Subject: Pressure and Temperature Limits Reports (PTLRs), Revision 2,
Braidwood Station, Units 1 and 2

Braidwood Unit 1, Pressure and Temperature Limits Report (PTLR)
Revision 2

List of Changes to the Unit 1 PTLR

Braidwood Unit 2, Pressure and Temperature Limits Report (PTLR), Revision 2

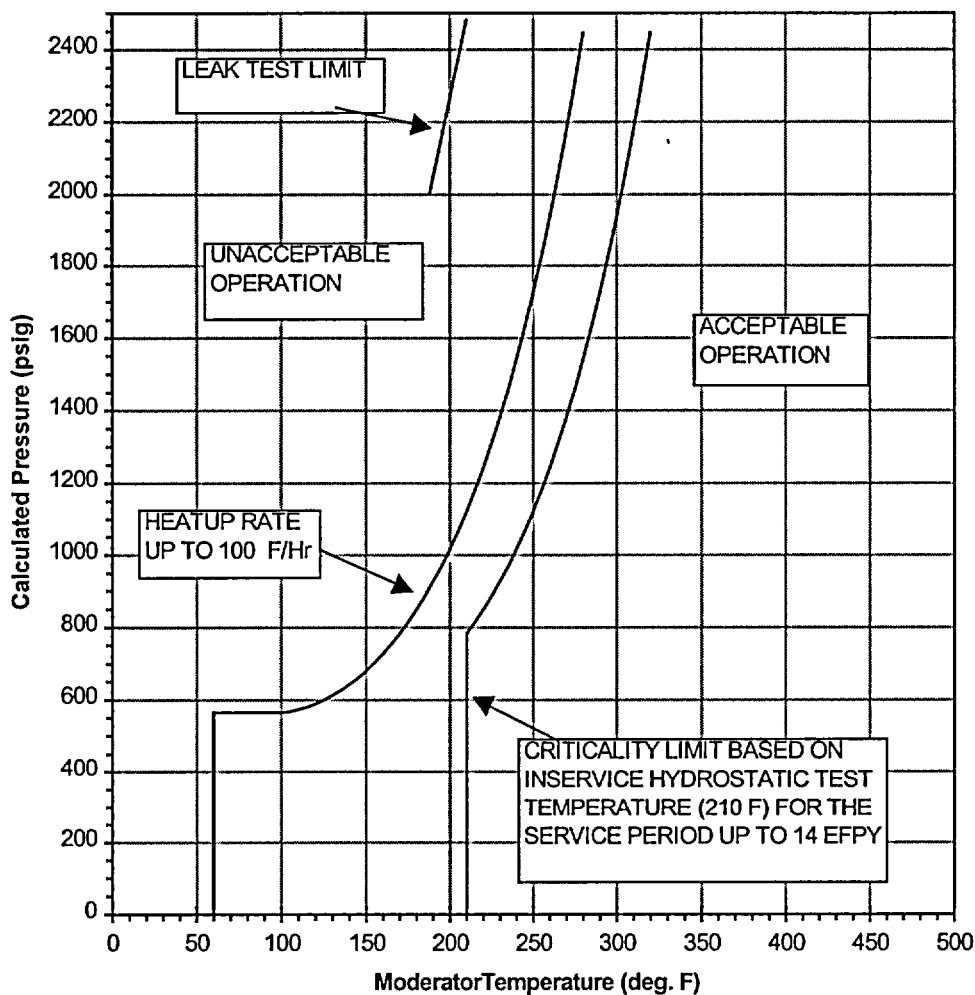
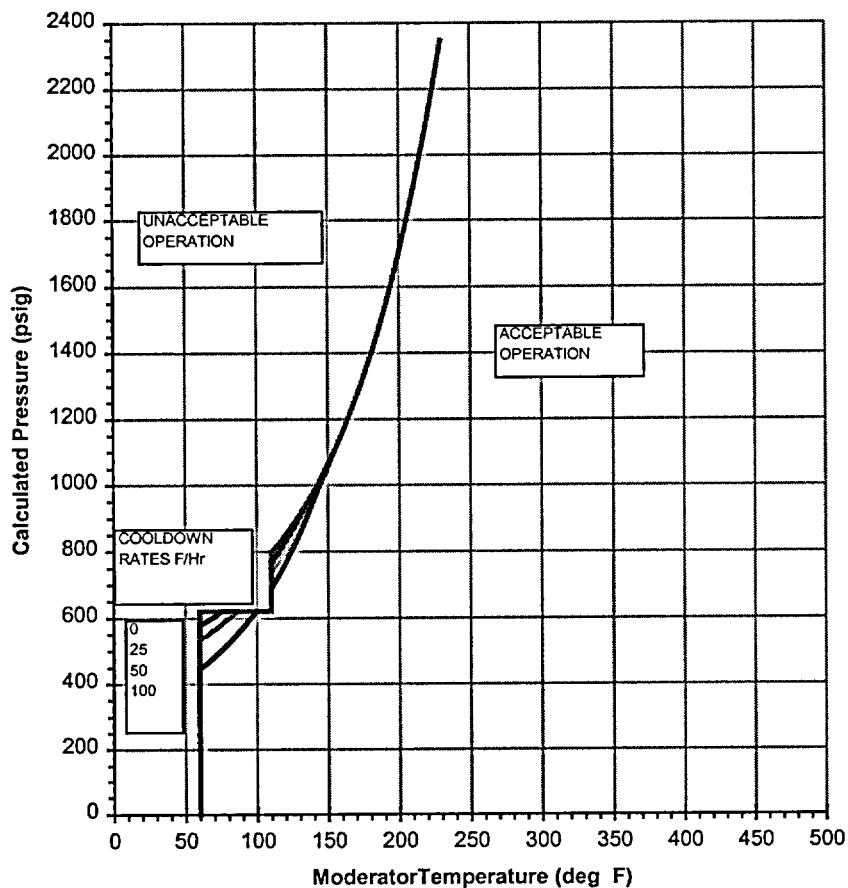
Page	Section	Previous	Revised to	Basis
II and III	List of Figures/ Tables	The description of Figures 2.1 and 2.2 and Tables 2.1a and 2.1b describe the heatup rate curve as "using 1996 Appendix G Methodology."	This description is removed.	<p>The Unit 1 PTLR does not use ASME Section XI 1995 edition, 1996 addenda. The Unit 1 PTLR curves are generated using Appendix G of the 1989 Edition of the ASME Section XI Code. The Unit 1 PTLR uses ASME Code Case N-514, "Low Temperature Overpressure Protection," which was later adopted into the 1995 edition with 1996 addenda.</p> <p>See WCAP-14243, "Braidwood Unit 1 Heatup and Cooldown Limit Curves for Normal Operations," Section 6.0.</p>
1	1.0	"This PTLR for Unit 1 has been prepared in accordance with the requirements of TS 5.6.6. Revisions to the PTLR shall be provided to the NRC after issuance."	"This Pressure and Temperature Limits Report (PTLR) for Braidwood Unit 1 has been prepared in accordance with the requirements of Braidwood Technical Specification (TS) 5.6.6, "Reactor Coolant System (RCS) Pressure and Temperature Limits Report (PTLR)". Revisions to the PTLR shall be provided to the NRC after issuance."	Editorial change. Sentence reworded for clarification.
